ILLINOIS POWER COMPANY

December 3, 1981

Clinton Power Station Unit 1
Docket No. 50-461

In order to address the issues raised by Questions 220.14, 220.15, 220.121, and 220.26 we met with the NRC staff on October 15, 1981. It was agreed in that meeting that a site specific spectrum for the Clinton site will be developed and used for a new soil spring SSI analysis. The effort to develop the site specific spectrum is in progress and is expected to be completed by early January 1982. Based on our initial evaluation it was determined that a 0.17 g Regulatory Guide 1.60 spectrum will envelope the site specific spectrum for Clinton.

FIGURE 220.15-26

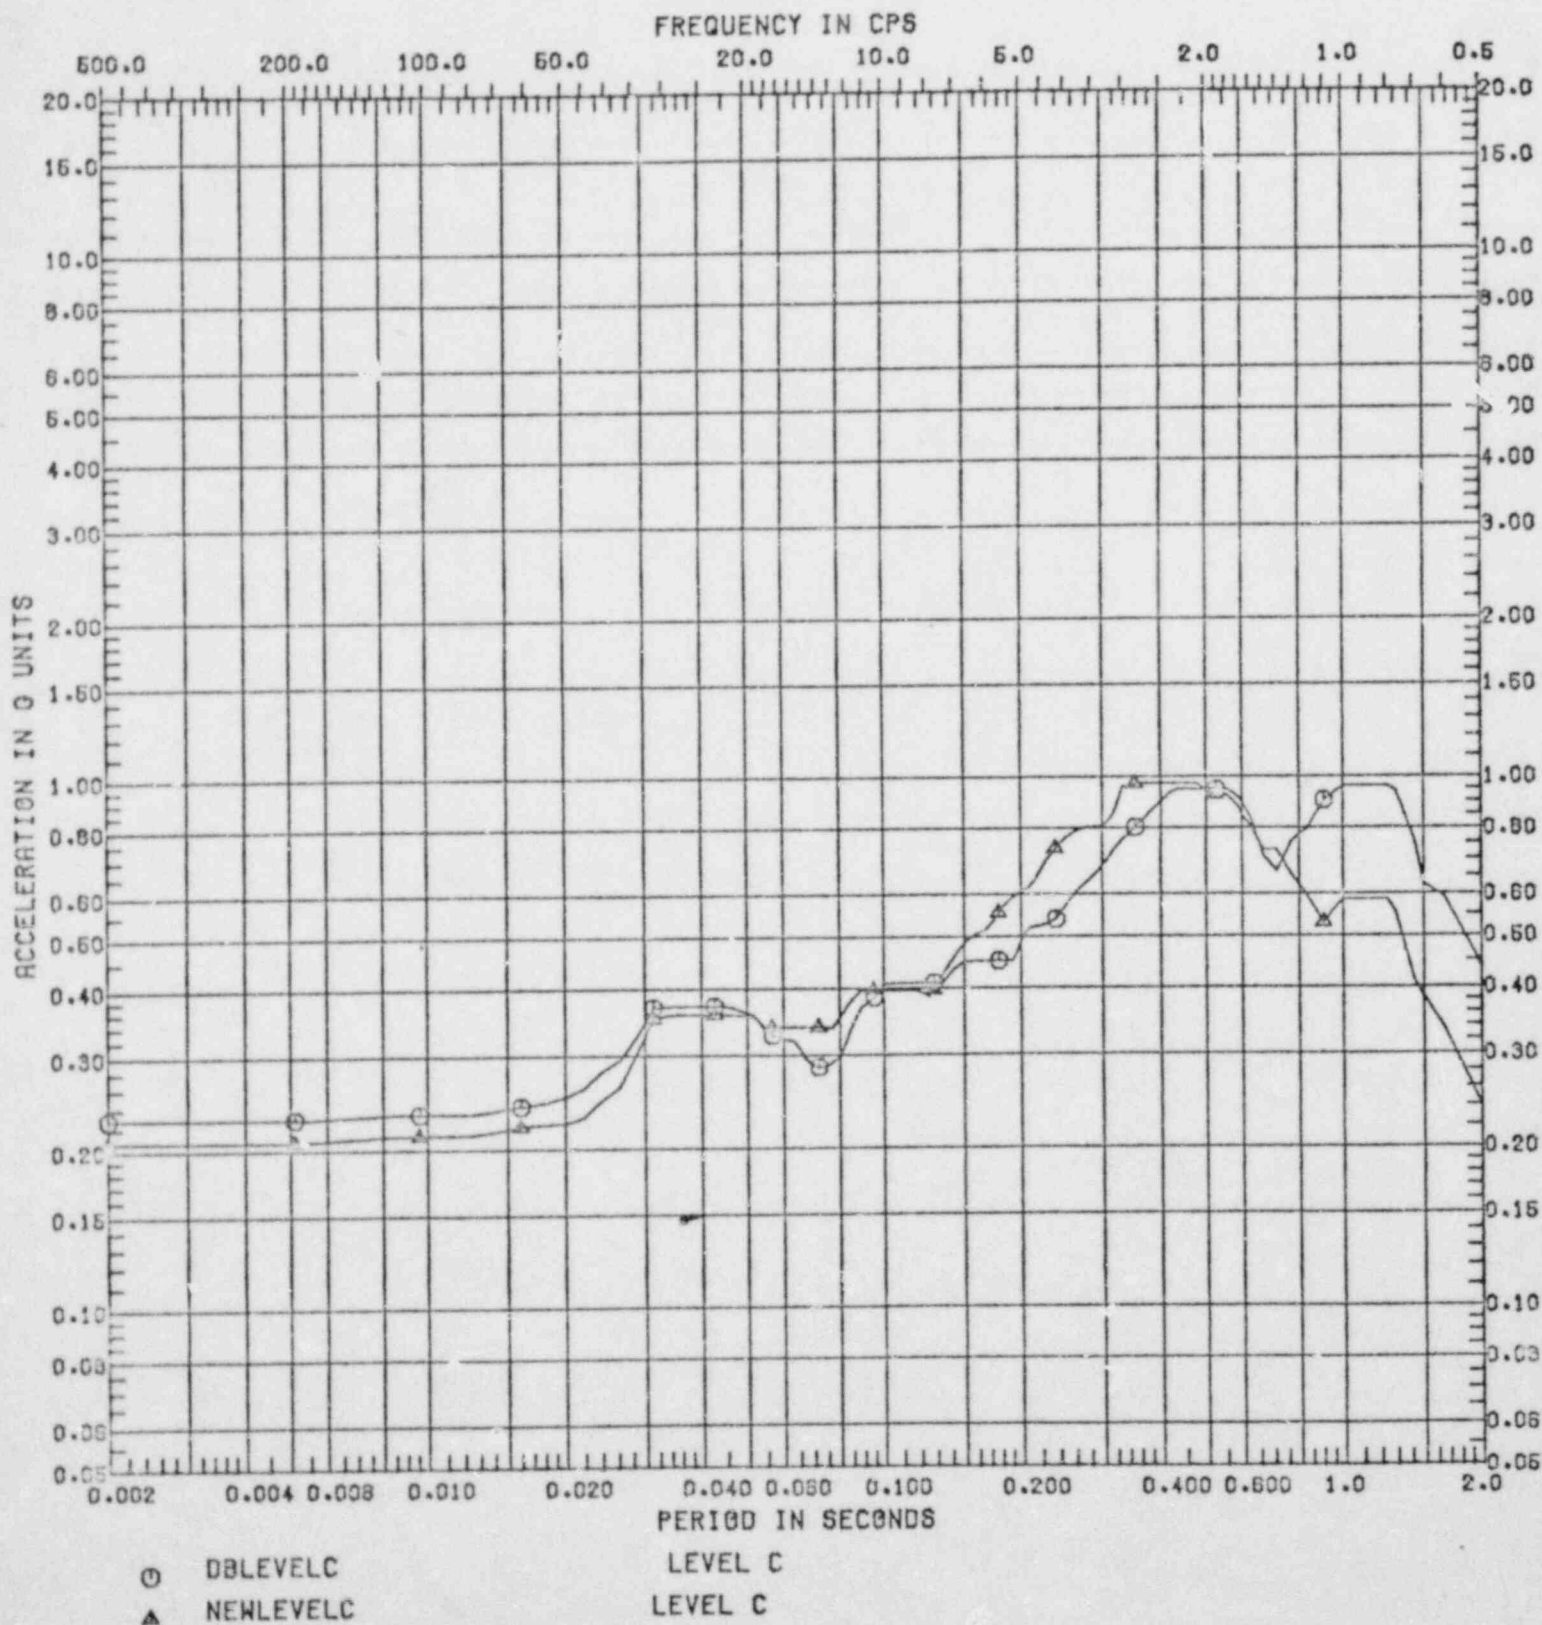
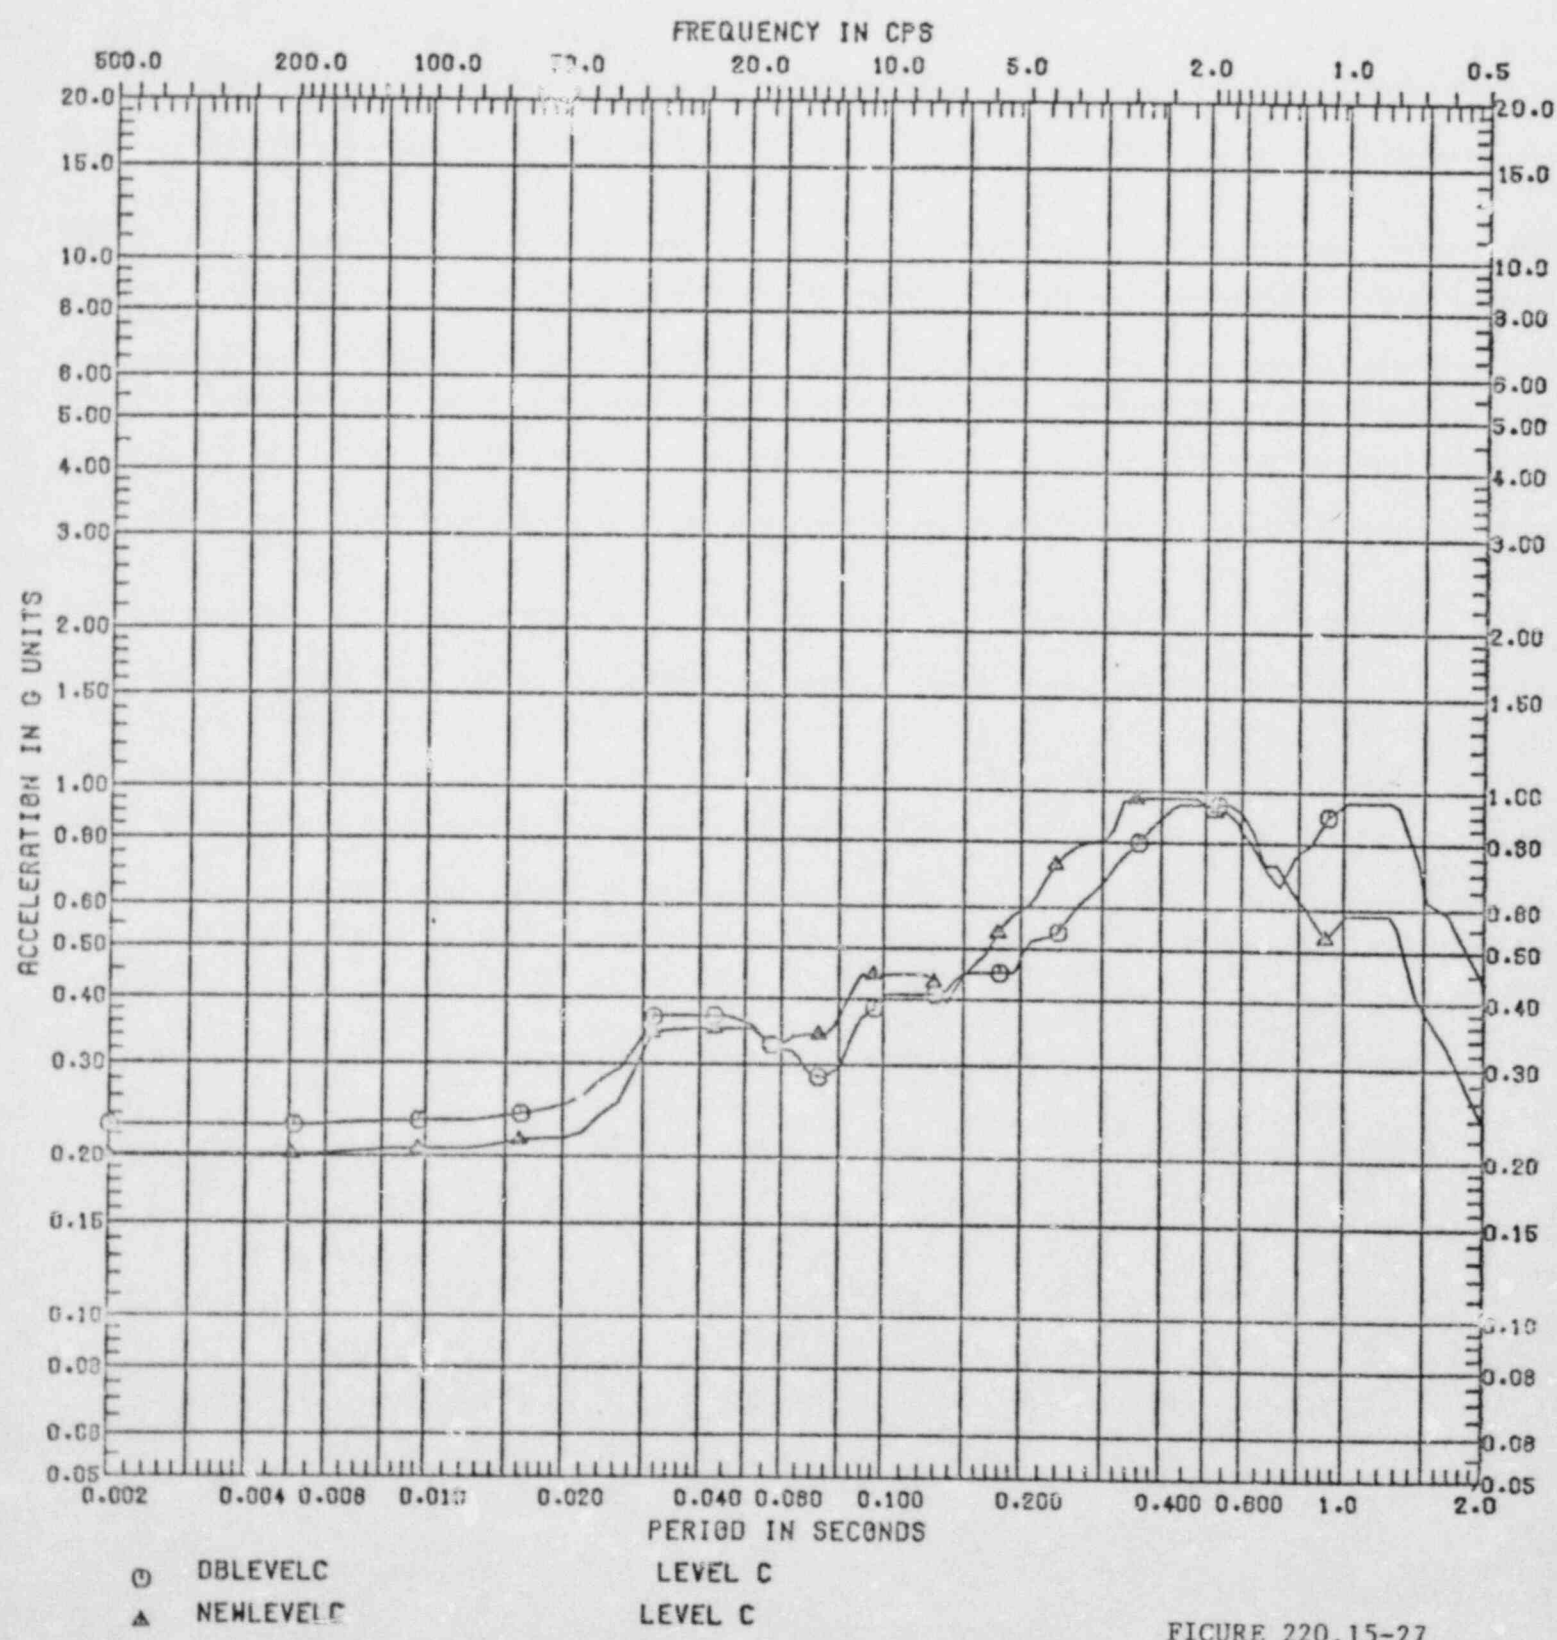
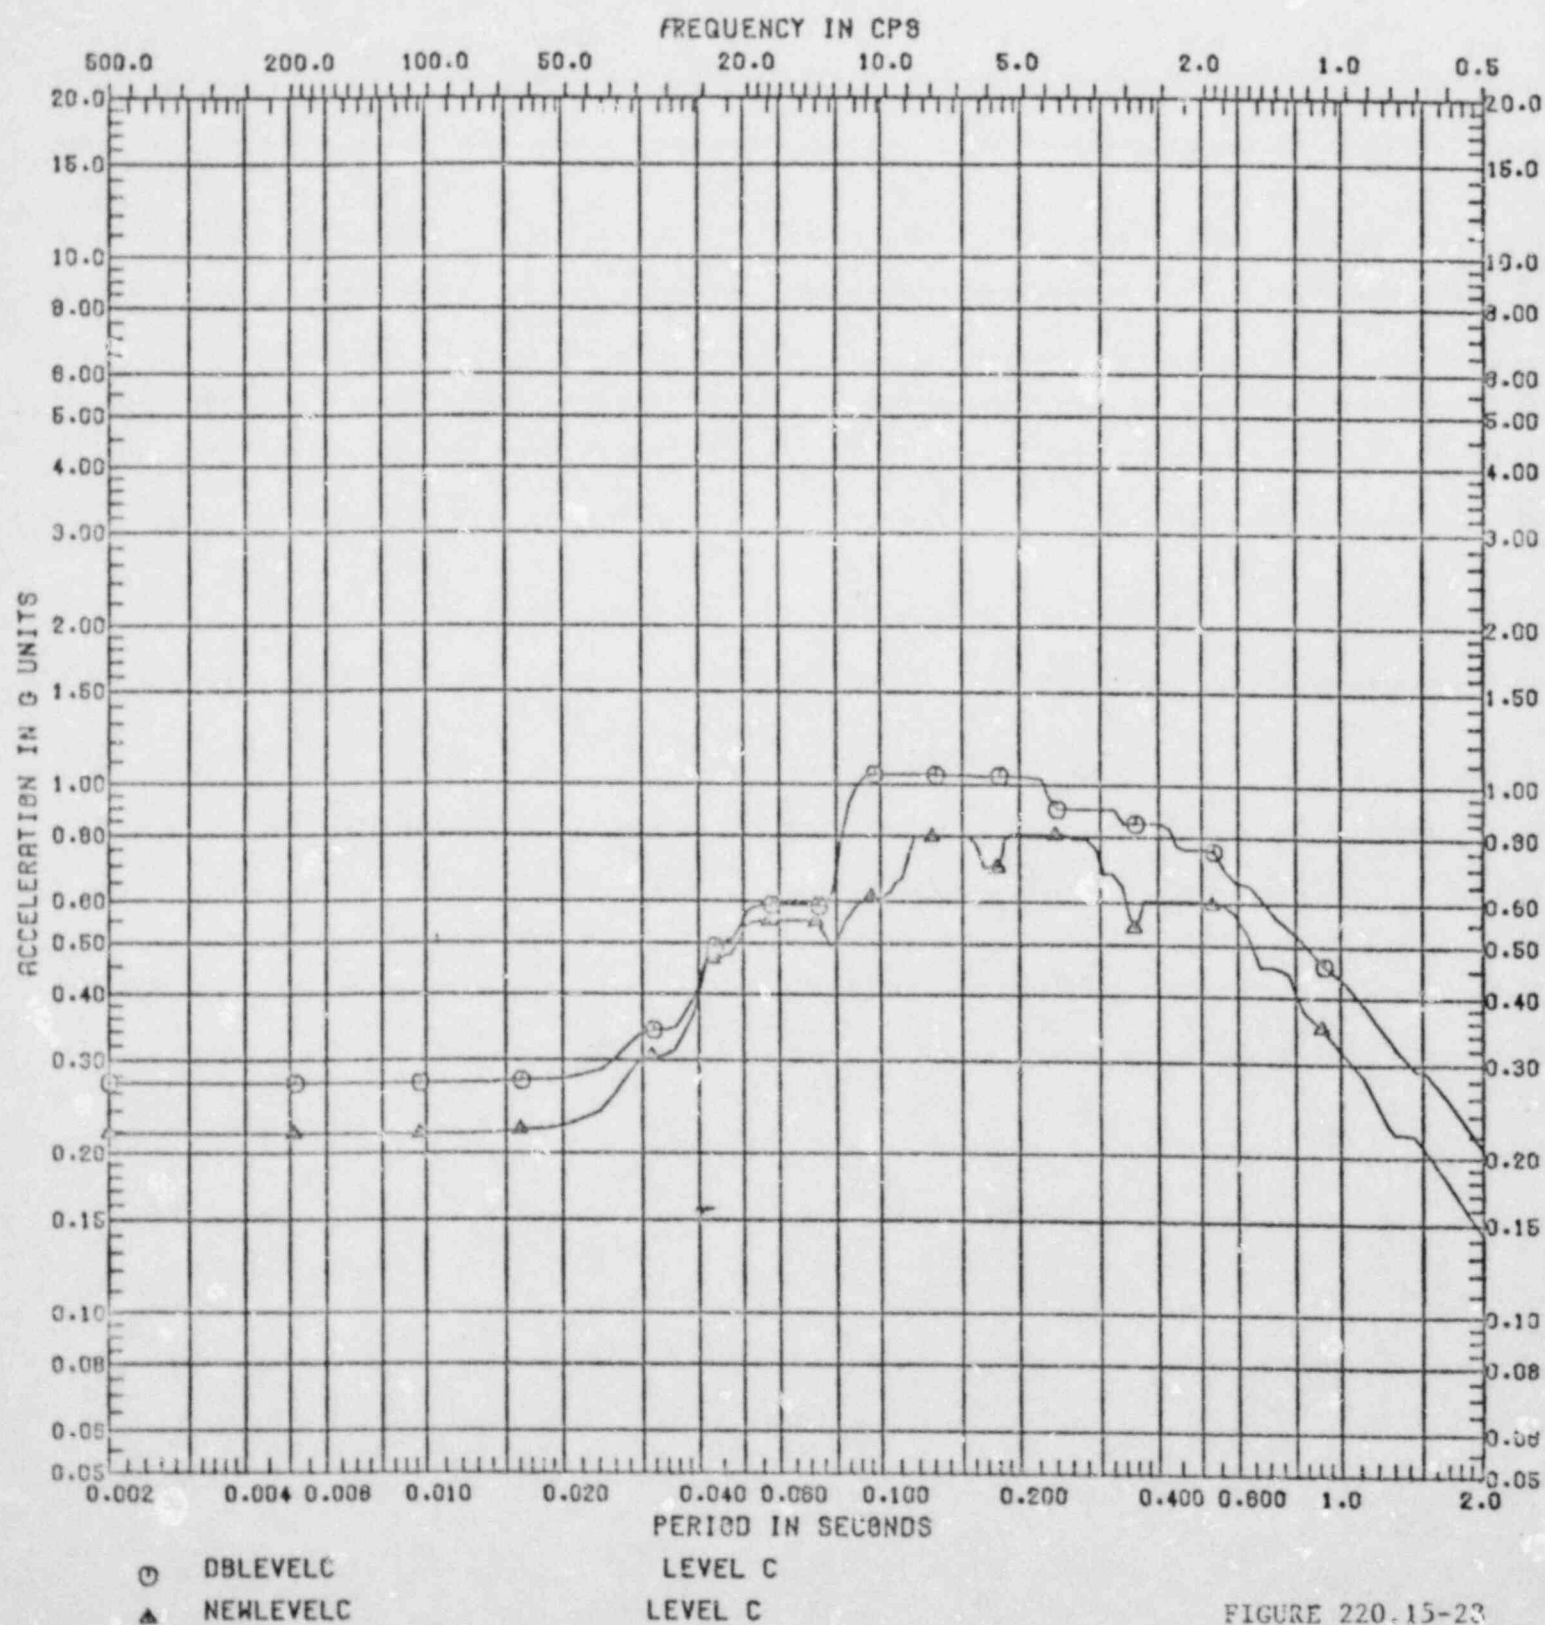
Our examination of Figures 3.7-12 through 3.7-27 indicate that at some frequency the free-field foundation level spectra is considerably less than the design response spectra as defined in FSAR, Section 3.7.1.1. Such reduction in design response spectra at foundation level is not acceptable to the staff. Either provide justification or use free-field motion at foundation level.

- a. Base Mat Elevation 712' for all buildings: comparison of combined spectra is shown in Figures 220.15-26, 220.15-27 and 220.15-28.
- b. Main Building Floor Elevation 762': comparison of the combined spectra is shown in Figures 220.15-29, 220.15-30 and 220.15-31.
- c. Containment Shell Elevation 803': comparison the combined spectra is shown in Figures 220.15-32, 220.15-33 and 220.15-34.
- d. Shield Wall and Pedestal at RPV Support Elevation 743': comparison of the combined spectra is shown in Figures 220.15-35 220.15-36 and 220.15-37.

The above Figures, 220.15-26 through 220.15-37, present the comparison of the combined SSE+SRV+LOCA floor response spectra obtained from the new soil spring SSI analysis to the combined spectra used for design. The spectra are for a 2% oscillator damping and are widened $\pm 15\%$. From these comparisons it can be concluded that:

- a. The new combined spectra for the vertical component ^{are} ~~is~~ enveloped by the design basis spectra.
- b. For the Containment ~~and the Pedestal~~ ^{are essentially enveloped by the} the horizontal ~~combined new spectra and design basis spectra, are essentially enveloped by the design basis spectra.~~
^{are essentially enveloped by the} combined new spectra ~~and design basis spectra, are essentially enveloped by the design basis spectra.~~
- b. ^{For the Main Building and the Pedestal} ~~For the Main Building~~ the new combined horizontal spectra ^{are} ~~is~~ higher than the design basis in the 2-6 Hz frequency range by approximately 10% - 20%.
